# SERVICE BULLETIN

Classification: RS11-004	Reference: NTB12-004	Date: January 9, 2012
-----------------------------	-------------------------	--------------------------

## SUPPLEMENTAL RESTRAINT SYSTEM (SRS) FRONT DOOR SIDE SATELLITE SENSOR INTRODUCTION

**APPLIED VEHICLES:** All 2011-2012 Nissan vehicles with SRS DTC B1338 and/or B1345 logic

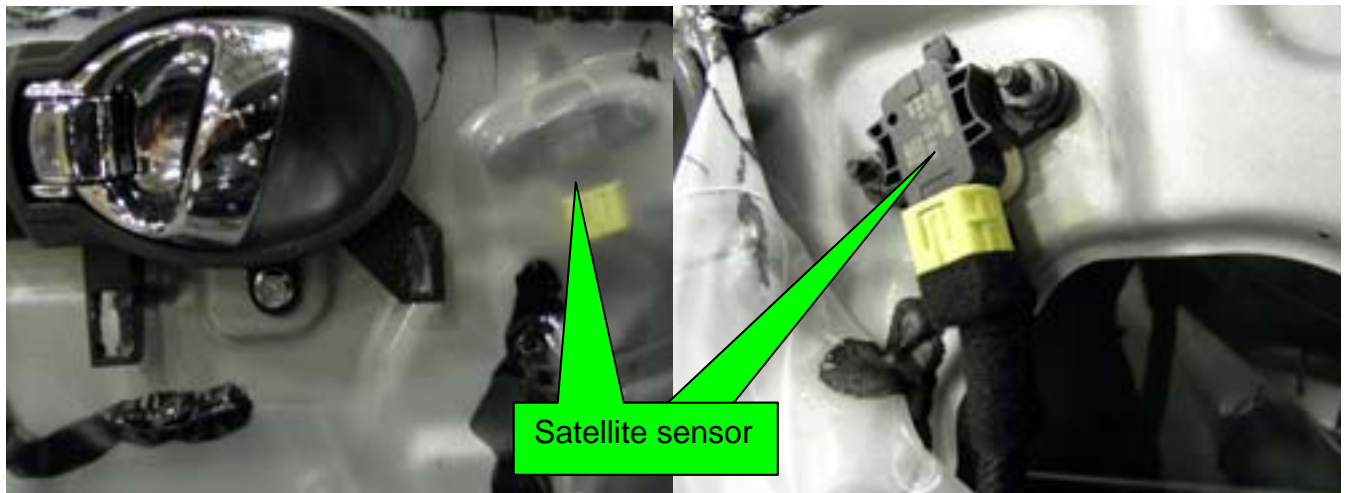
The Applied Vehicles now come equipped with a “Front Door Side Satellite Sensor”, in addition to the pre-existing Side Air Bag Satellite Sensor found in the pillar.

These Sensors have new Diagnostic Trouble Codes (DTC) associated with them.

**IMPORTANT:** If the front door internals are being serviced for any reason, and this Sensor is unplugged or reconnected with the ignition ON, **the following codes could be stored:**

- B1338 and/or B1345 - SATELITE SENSOR LH or RH.

- The code(s) is a “PAST” code **only**.

**NOTE:** When diagnosing the DTCs listed above, be aware of this potential sequence of events.
